FURNACE DOCK SUBDIVISION

ENVIRONMENTAL IMPACT STATEMENT

Furnace Dock Road
TOWN OF CORTLANDT, WESTCHESTER COUNTY, NEW YORK
Tax Map Number: Section 55.19, Block 1, Lot 1

**FURNACE DOCK SUBDIVISION
Final Environmental Impact Statement**

Figure 5-1: Conceptual Location for Wetland Mitigation Areas

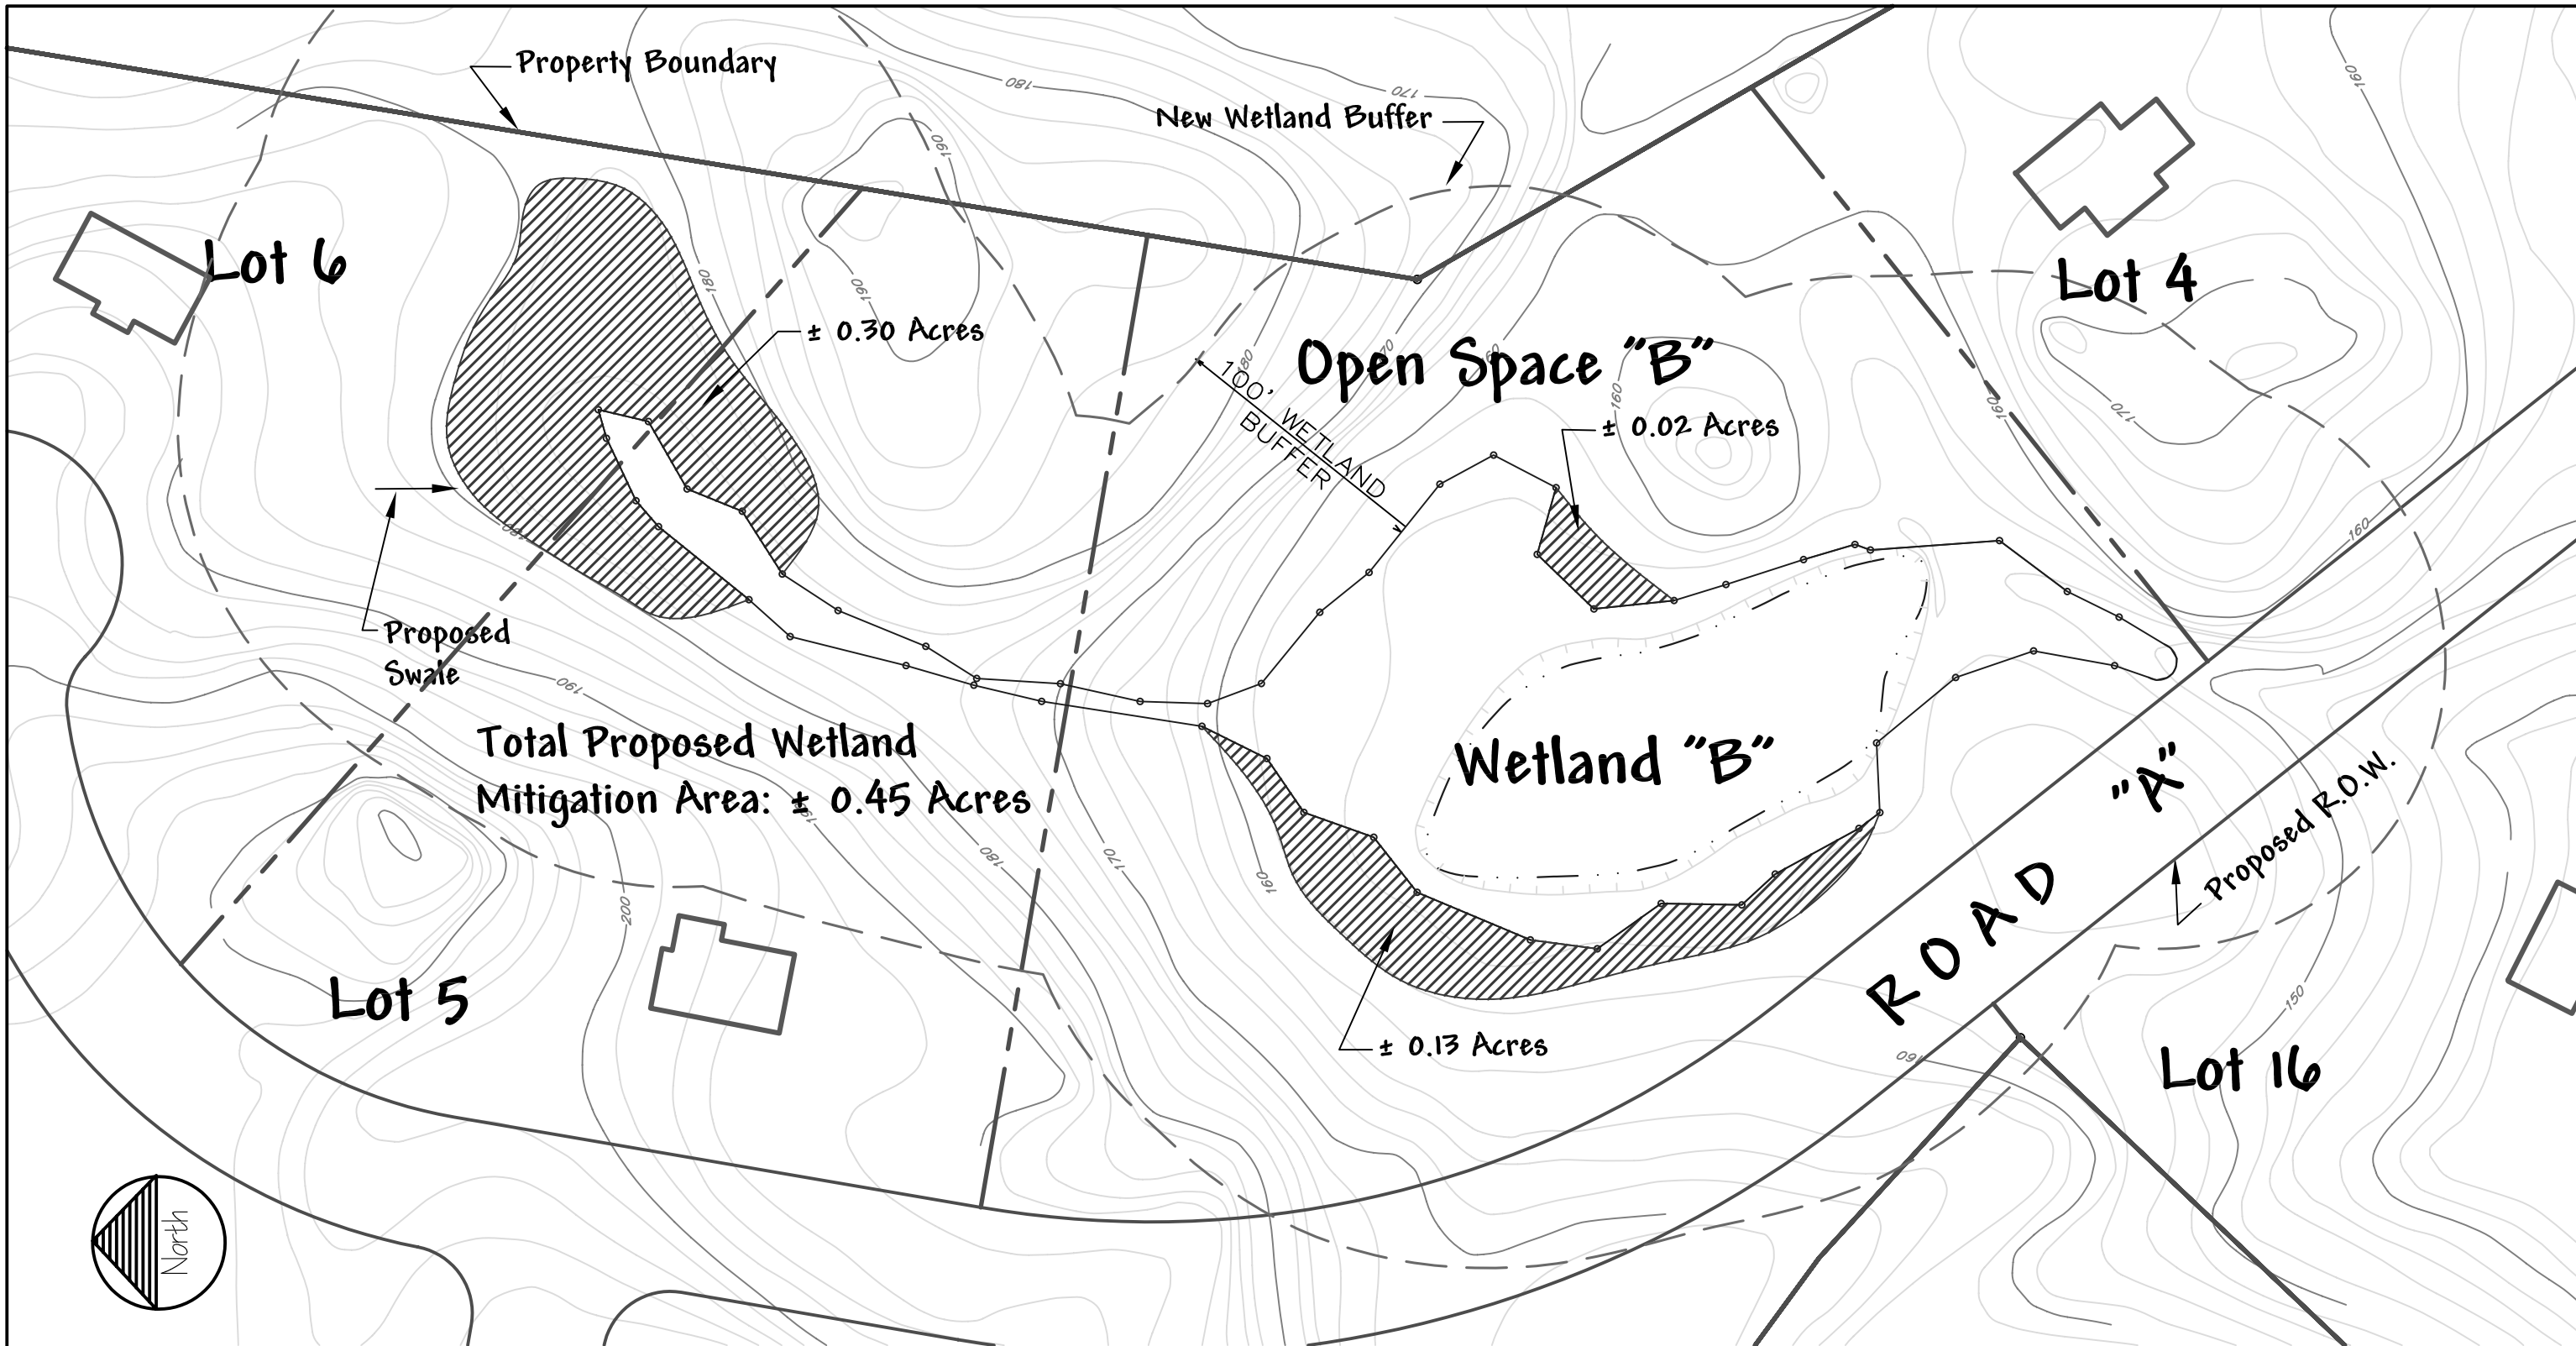
The proximity of the mitigation areas to the proposed residences is shown in FEIS Figure 5-1. This figure also shows the limits of a 100-foot buffer as it extends from the boundary of the proposed mitigation areas. As this line does not represent a current regulatory buffer because the wetland creation areas have neither been approved nor constructed, it is not shown on the engineer's site plan.

Response 5-15: *Private ownership of wetland areas is common, and property owners are responsible for adhering to the various federal, state and local laws that regulate use of such areas. The proposed wetland mitigation (FEIS Figures 5-1 and 5-2) is an expansion of an existing wetland area (Wetland "B") and is within areas to be conservation easements. As part of the project plan, the applicant would maintain the proposed mitigation area for five years to ensure that it is fully established and functioning as designed. Beyond that period, further maintenance should not be required as it will function as a natural system. A conservation easement is proposed to protect the created wetlands. The encumbrances created by the conservation easement and created wetland boundaries will be described on the deed and shown on the approved plat. In addition, permanent markers will be placed at the site to mark the conservation easement boundaries to facilitate monitoring of the wetland mitigation area*

Figure 9-1: 17-Lot Alternative Plan
Furnace Dock
Town of Cortlandt, Westchester County, New York
Source: Ralph G. Mastromonaco, P.E., P.C., 01/05/06
Scale: Graphic

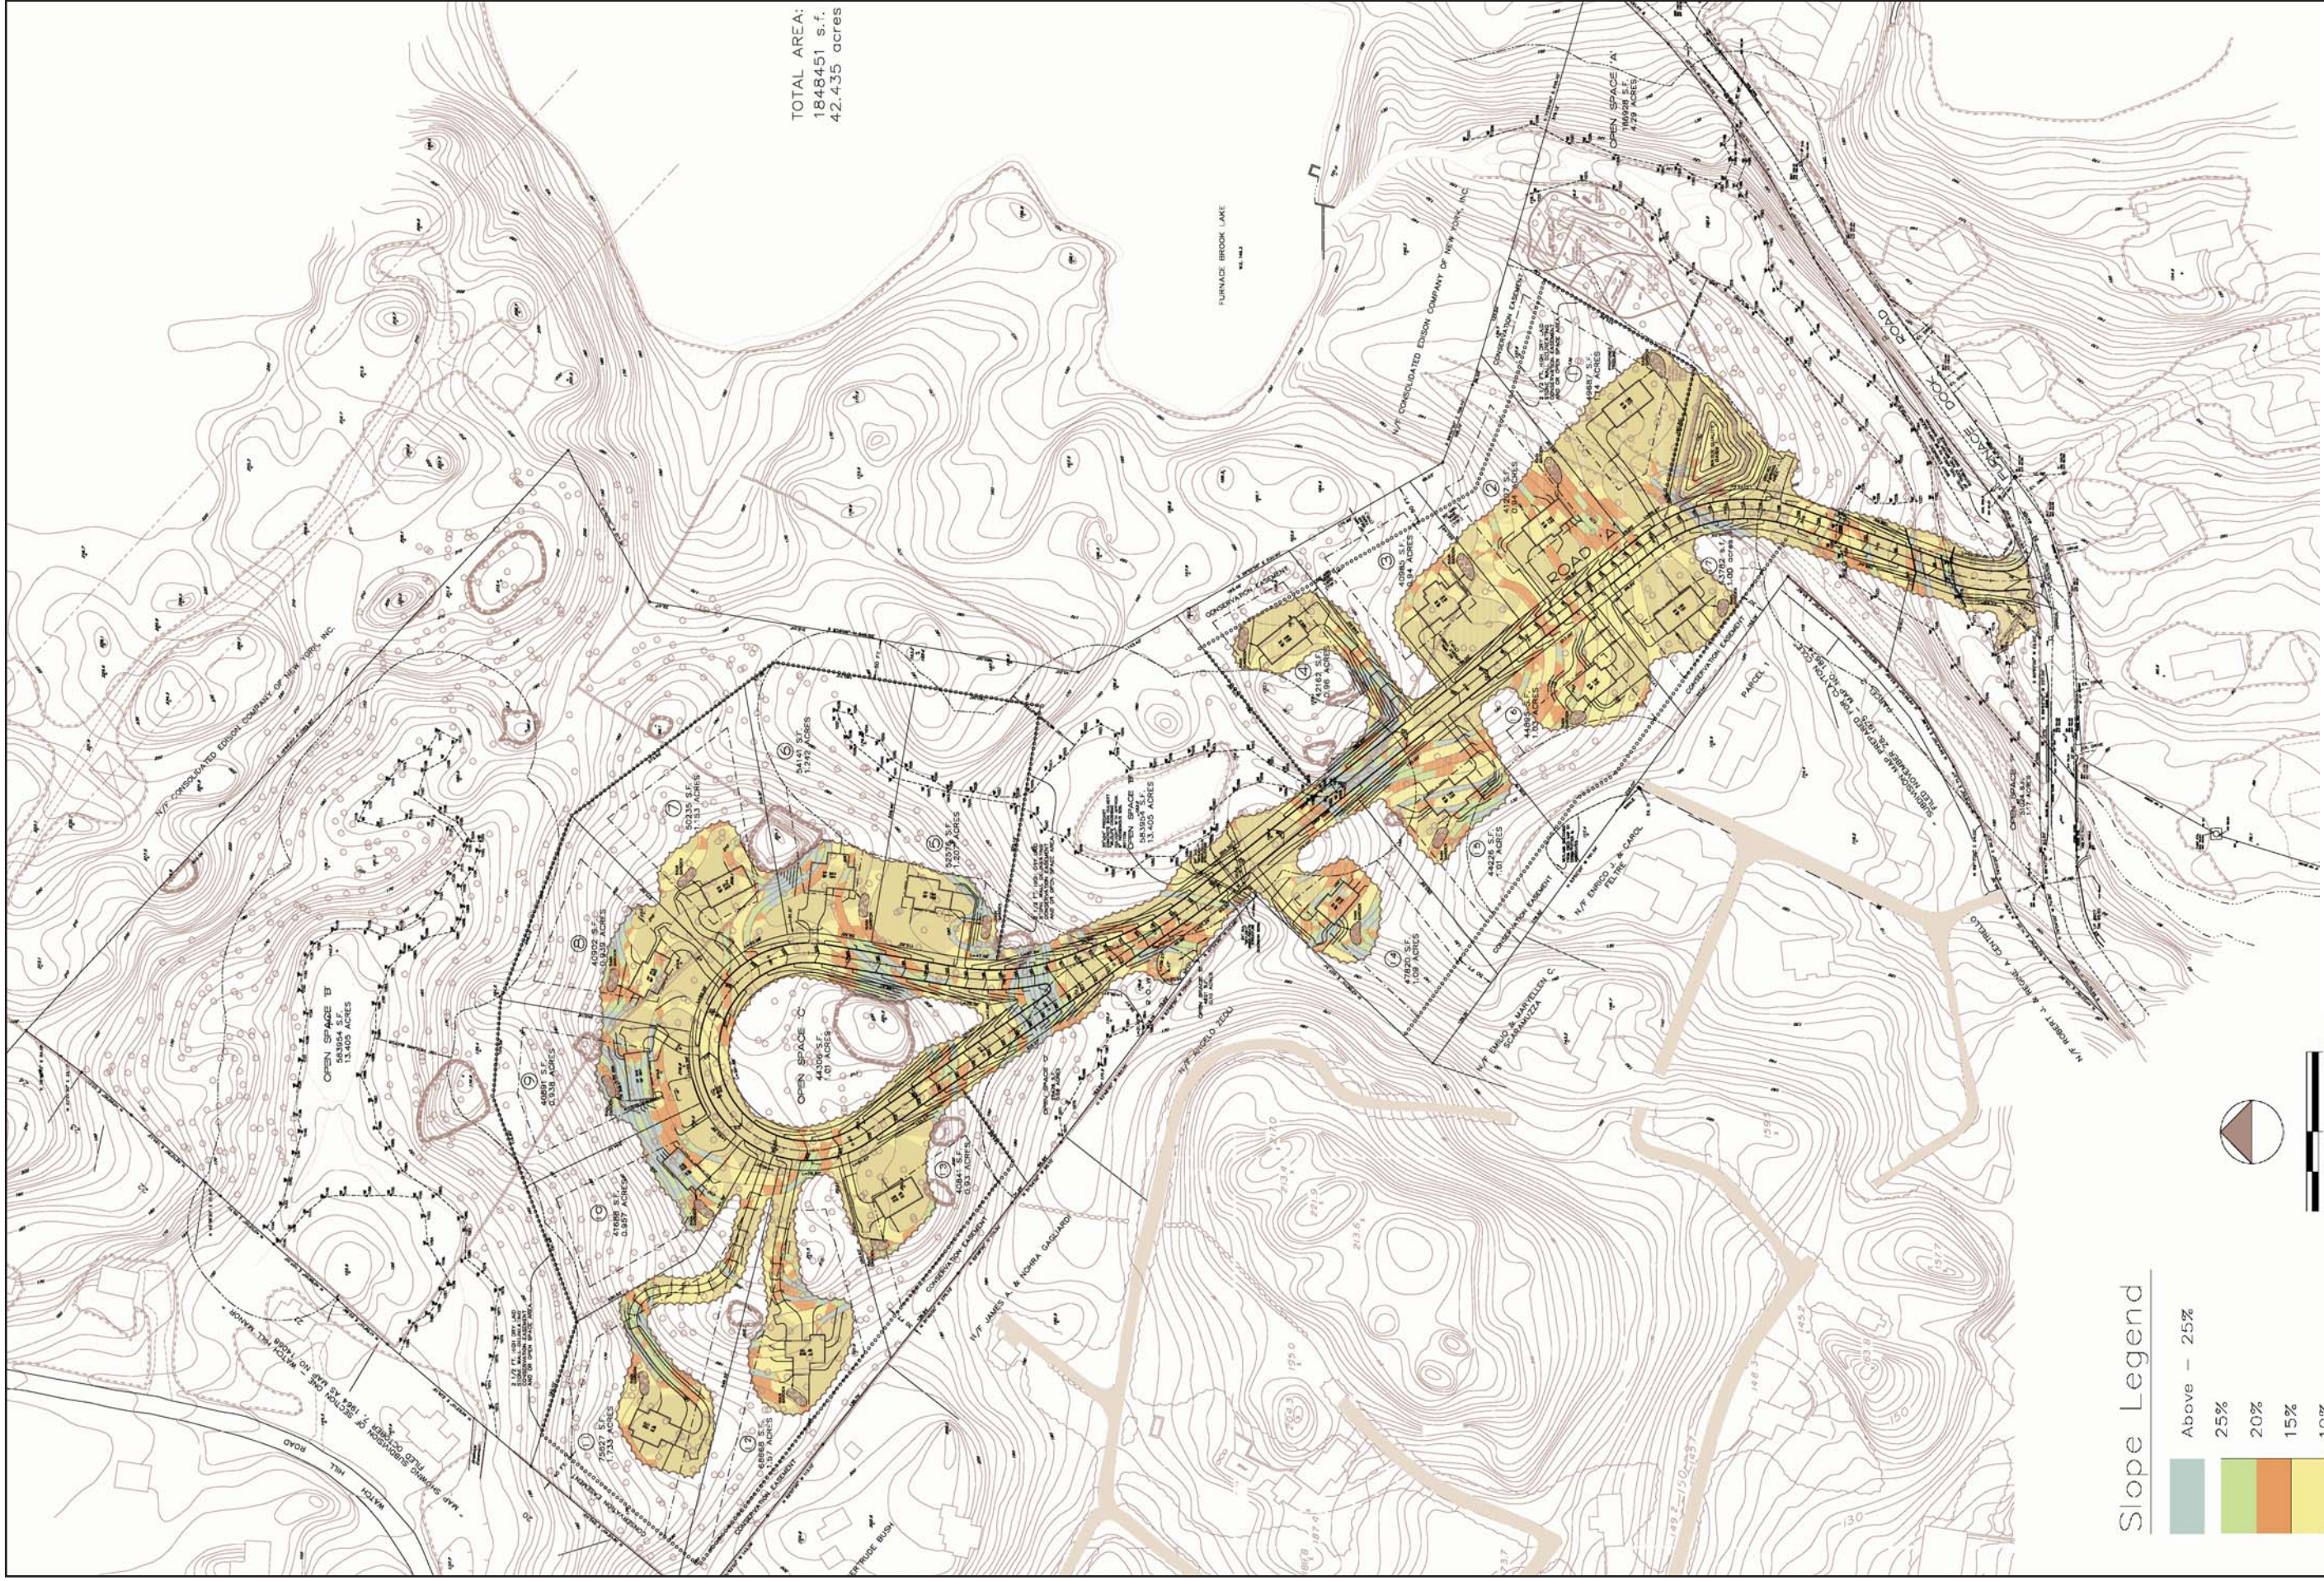
Comment 5-19 (Letter #9, Ed Vergano and Ken Verschoor, November 20, 2003): The Town Wetland Consultant for this application should review the proposed subdivision to further advise the Planning Board.

***Response 5-19:** Mr. Stephen Coleman has reviewed the proposed 18-lot subdivision plan, an 18-lot alternative loop road plan, the recommendations of Dr. Klemens, and the draft responses in the FEIS. In response to Mr. Coleman's December 2005 comments (included in FEIS Appendix A), the applicant has revised its initial 18-lot loop road plan with regard to natural connections between wetlands. The revised 17-lot Alternative Loop Road Plan is presented in Chapter 9.0 of this FEIS. Particular elements of the loop road plan reflect specific recommendations of Mr. Coleman with regard to preserving*

wildlife corridors and limiting fragmentation of regional habitat. These elements are listed in FEIS Section 1.2.
